SUBJECT: Duke Energy Corporation

Oconee Nuclear Station Units 1, 2, & 3
Docket Nos. 50-269, 50-270, 50-287

Nuclear Quality Assurance Program
Amendment 31

Pursuant to 10CFR50.54 (a) (3) and 10CFR50.71 (e), attached is Amendment 31 to the Duke Energy Corporation Topical Report, Duke-1-A, *Quality Assurance Program* (hereafter referred to as Topical Report). Amendment 31 includes organizational changes, administrative and editorial changes.

Figure 17-2 Duke Energy Corporation Corporate Organization

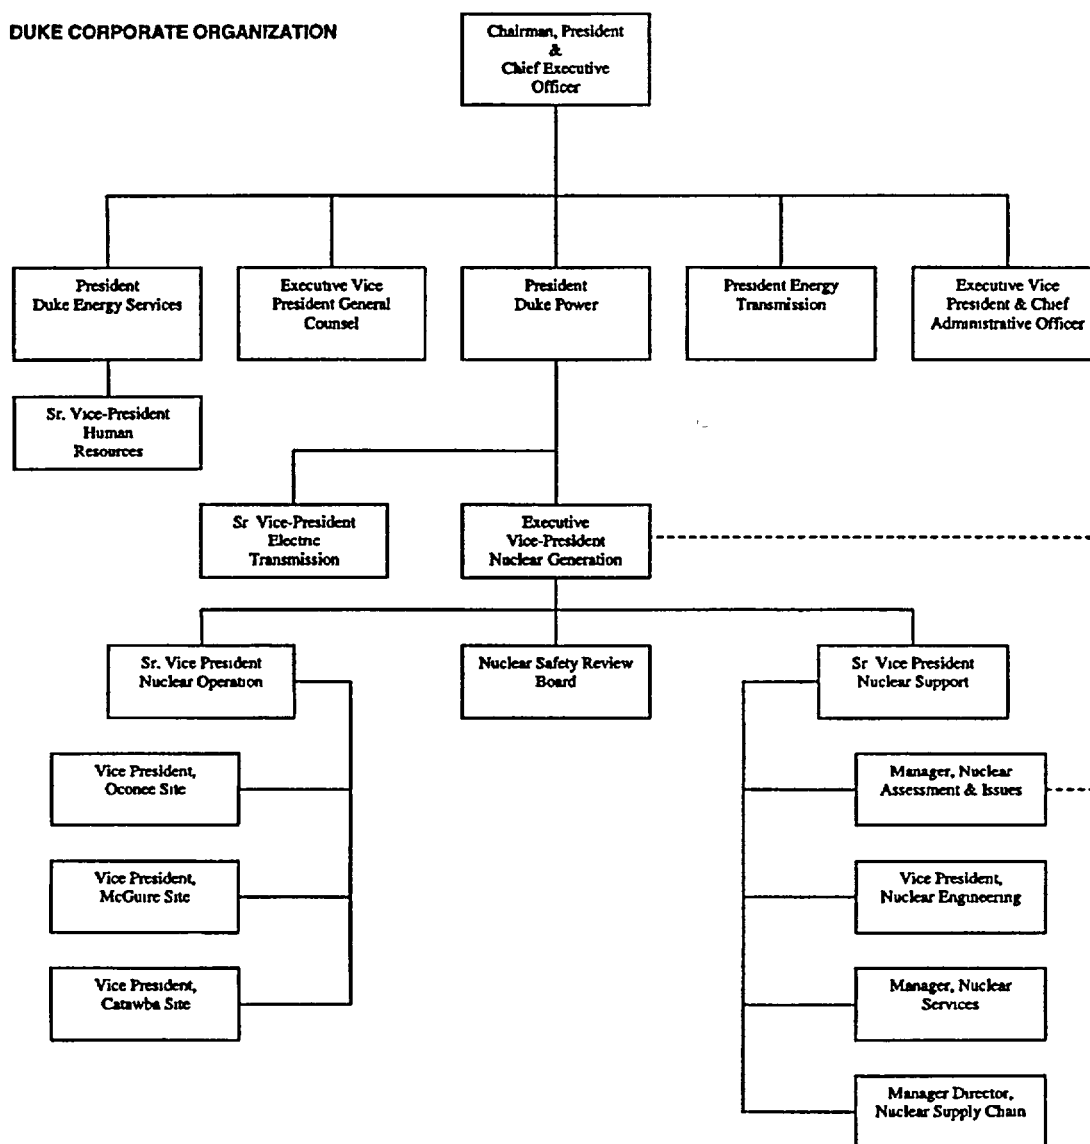
4. **Various Editorial and Administrative Corrections** made throughout the document as deemed appropriate.
5. **Figure 17-2 Corporate Organization**, revised the chart to reflect corporate organizational changes.

Description of Change: The changes described above as Items 1, 2, 5, 6, and 7 resulted from organizational changes.

Reason for Change: The primary reason for implementing these items is to ensure that the wording and organizational descriptions reflect the present organizational structures.

Figure 17-3 Off-Site Organization

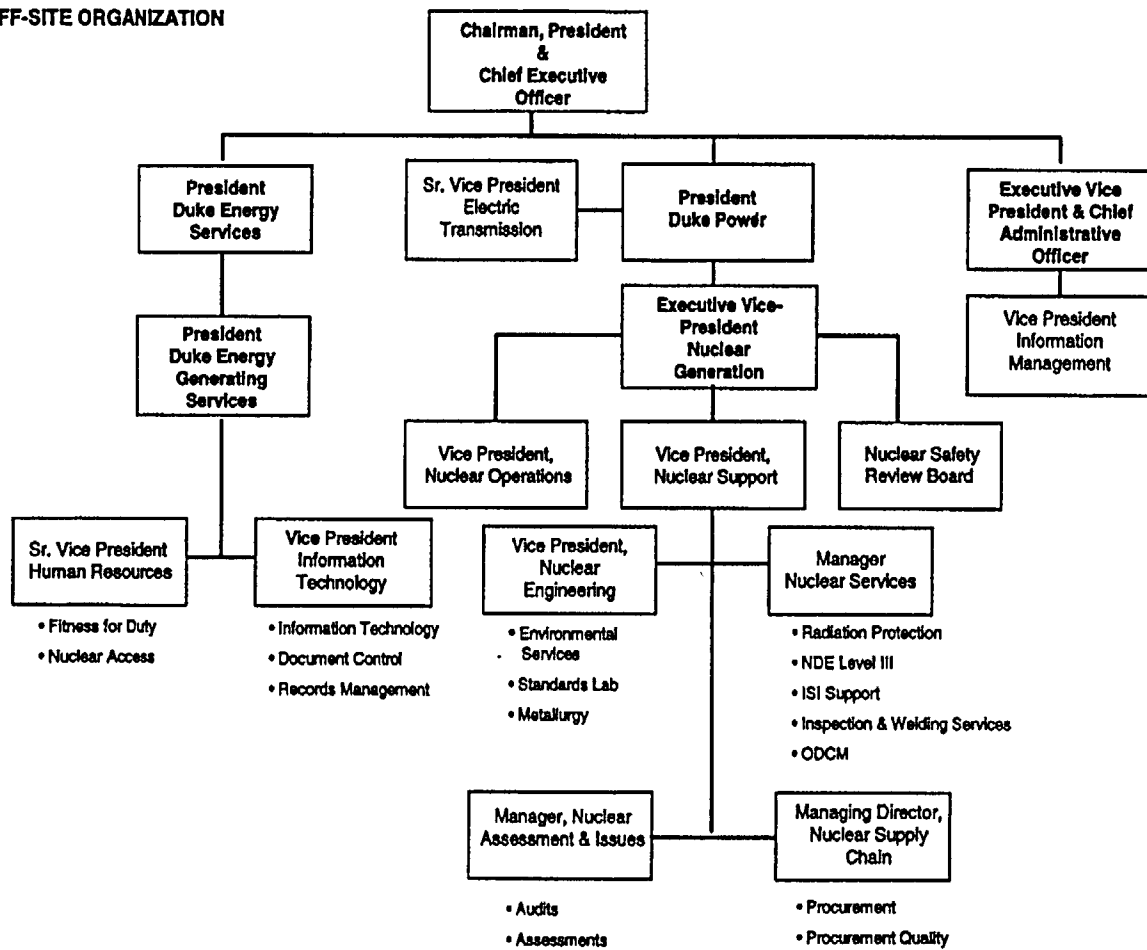
6. **Figure 17-3 Off-Site Organization**, revised chart to reflect corporate organizational changes.
7. **Figure 17-4 Nuclear Site Organization**, revised chart to reflect corporate organizational changes.
